RFI

RFI #: 28
Date: 12/17/2019
Job: 18-075 LDS Wolftrap
Phone:

Subject: Shed/Dumpster Enclosure Dimensions

**CROWELL ROAD
MEETING HOUSE
OAKTON VA STAKE**
CROWELL RD AND HUNTER MILL RD
FAIRFAX, VIRGINIA 20190

Sheet:
A802

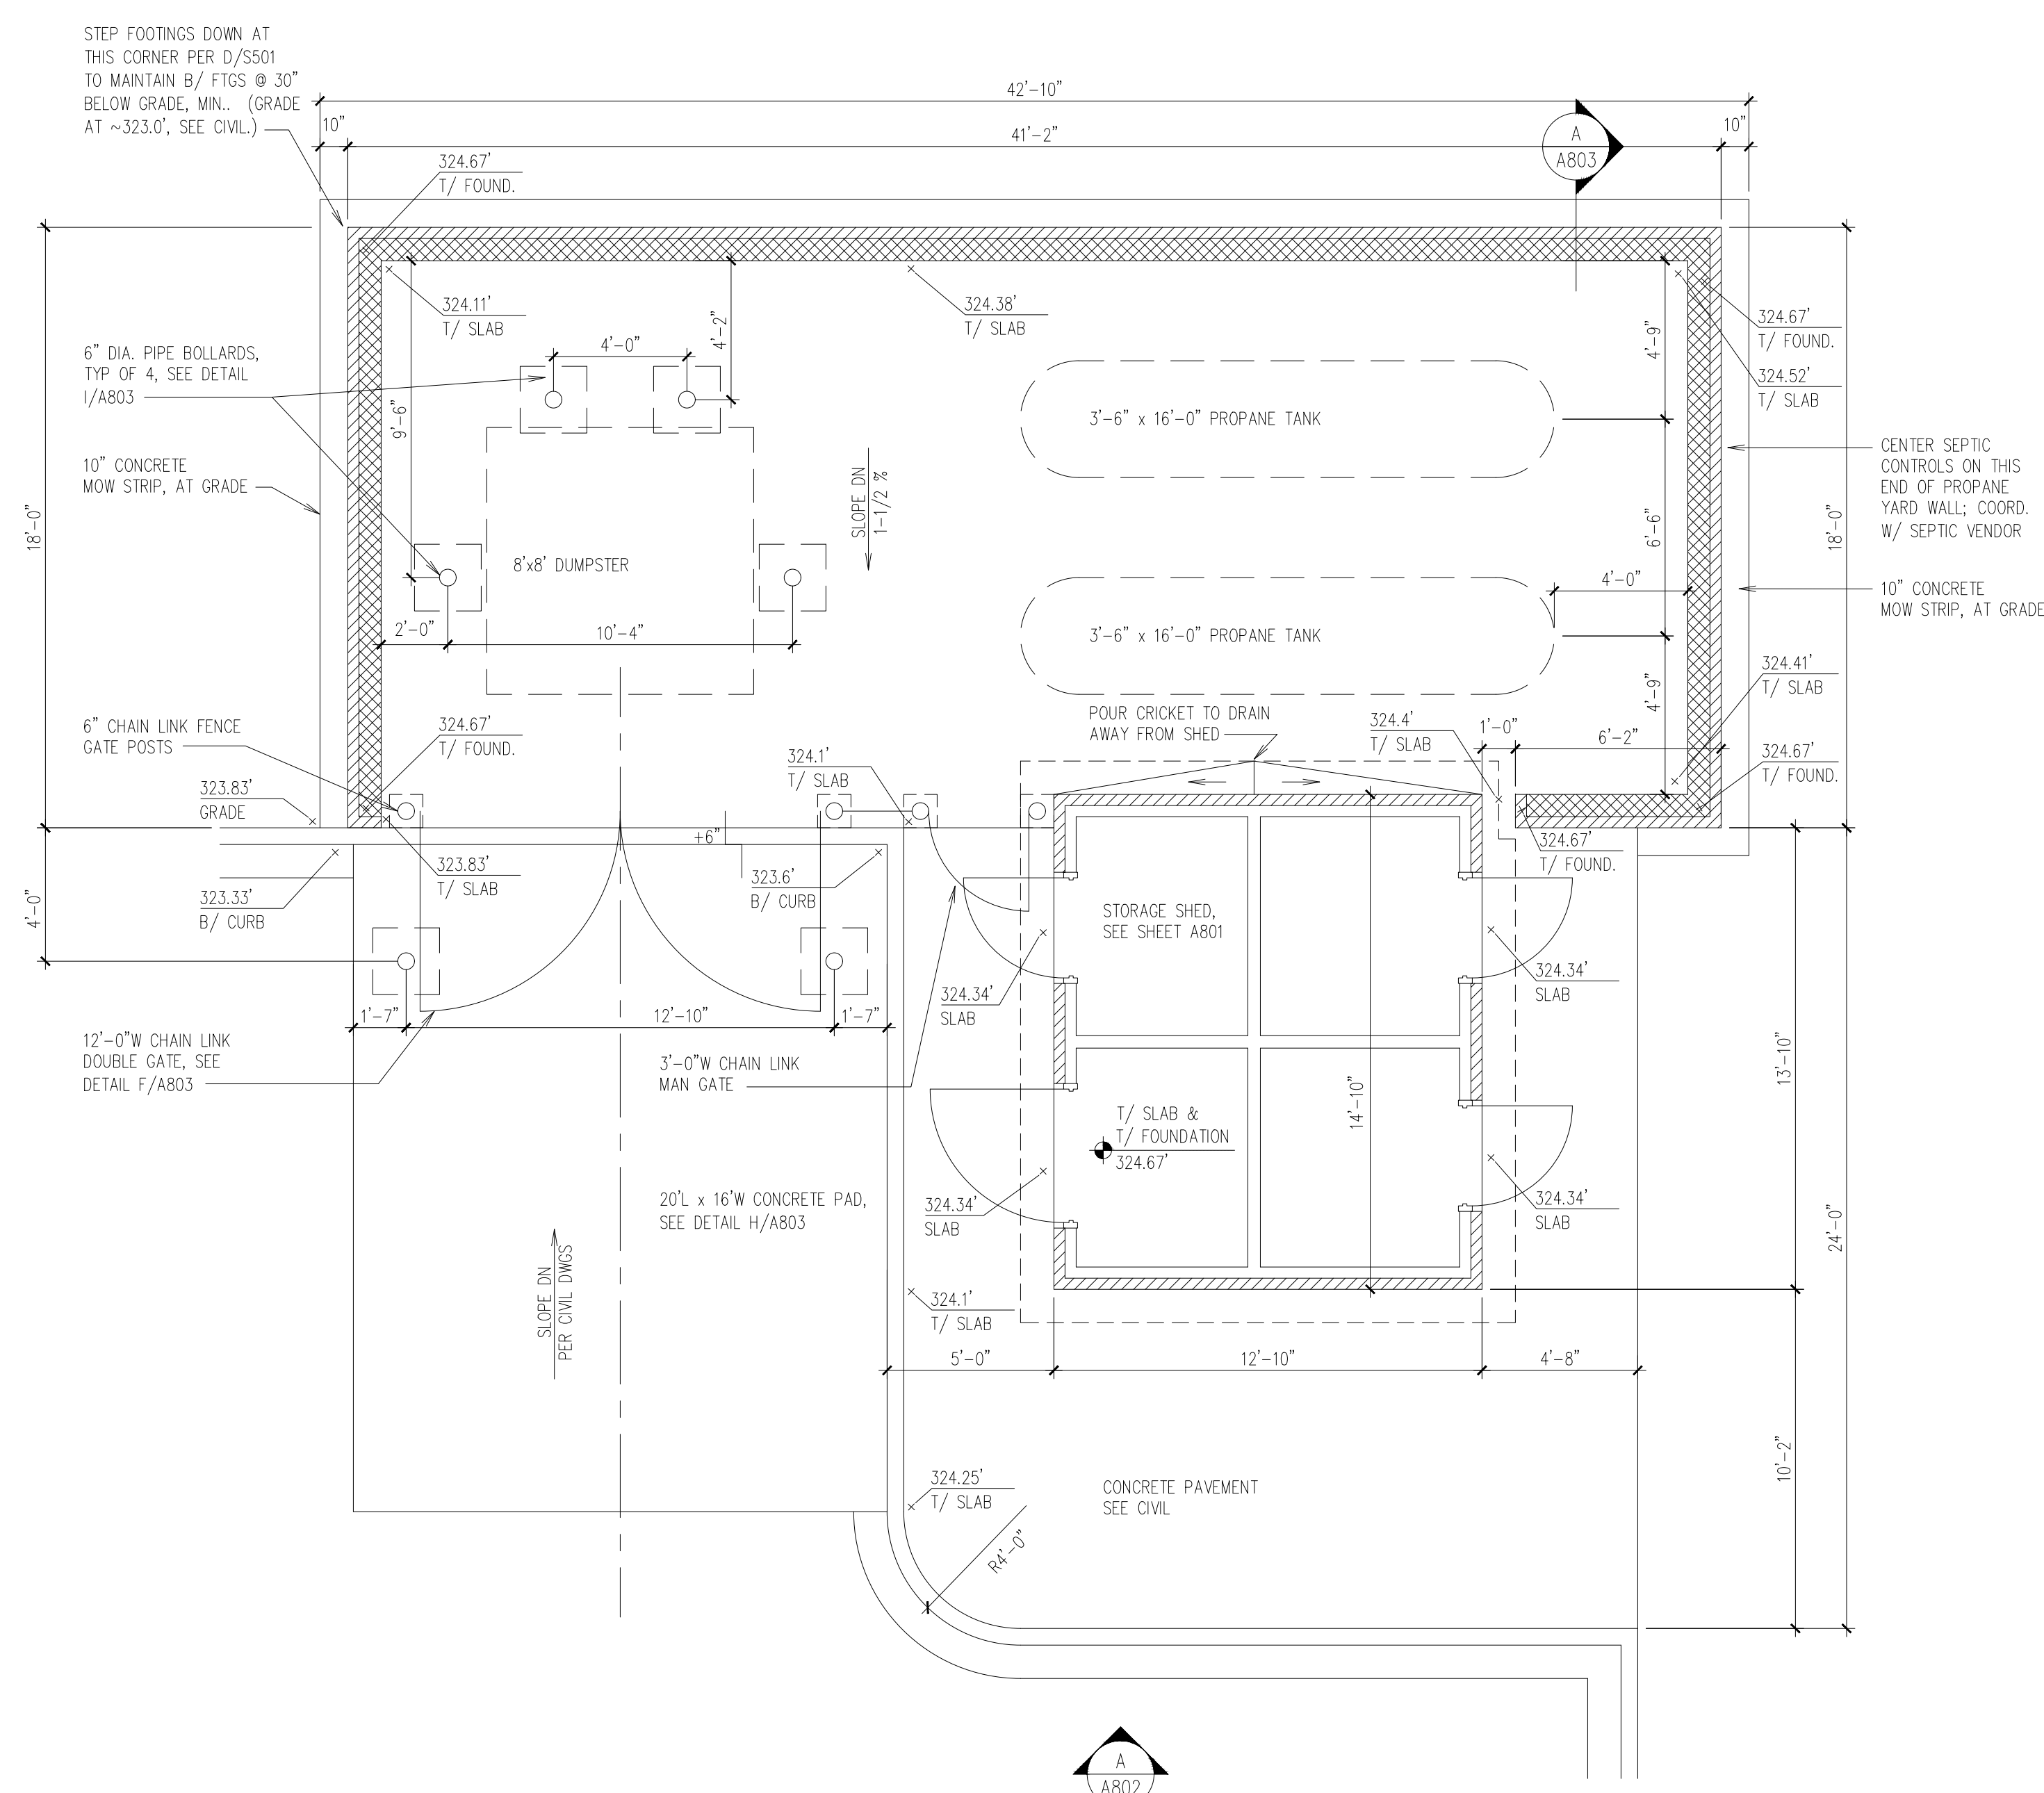
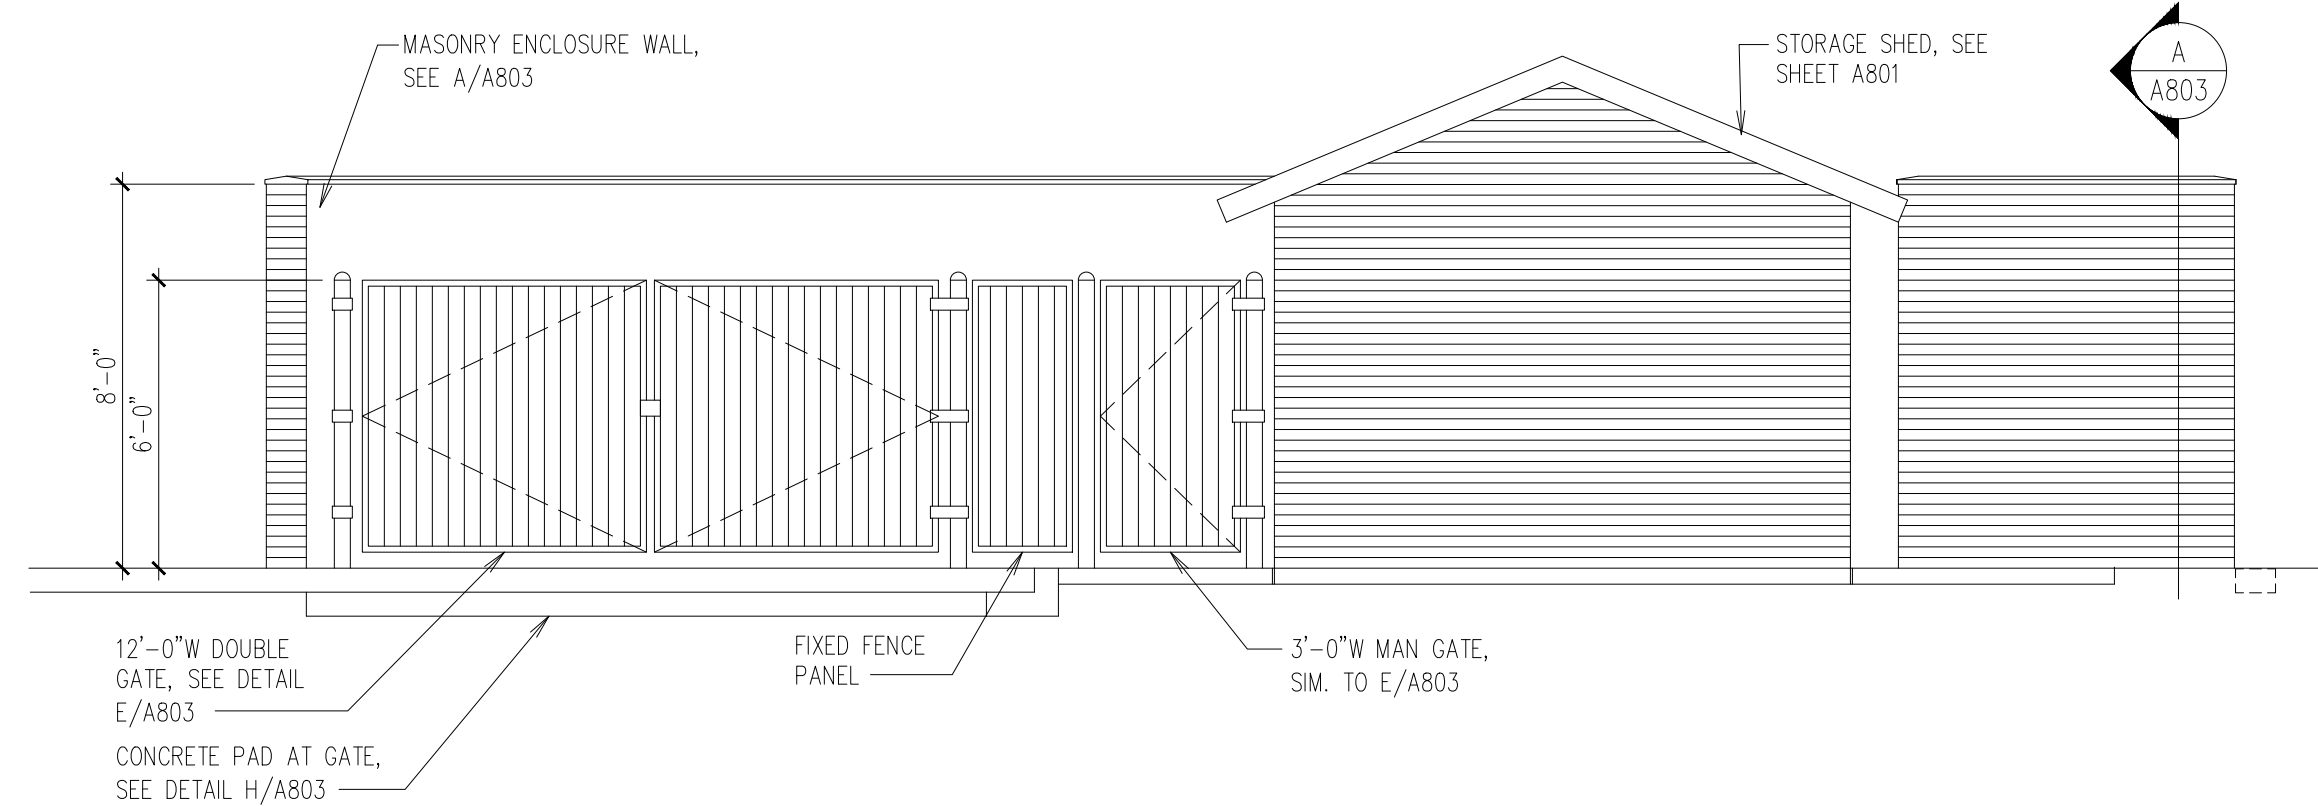
The concrete contractor has noticed a bust in the dimensions that Urban had set in the field. Sheet A801 calls out for the outside of shed concrete foundation to be 12'-9" X 14'-9" and sheet A802 shows the outside brick dimension as 12'. If the dimensions on sheet A801 are to be used the dimensions on sheet A802 will need modified. Can you provide us with the correct dimensions?

Please see attached Sheets A801 and A802, issued with today's date with corrected notes and dimensions. 1/A801, 4/A801 & 1/A802 have been updated in whole or in part, as indicated by the clouds.
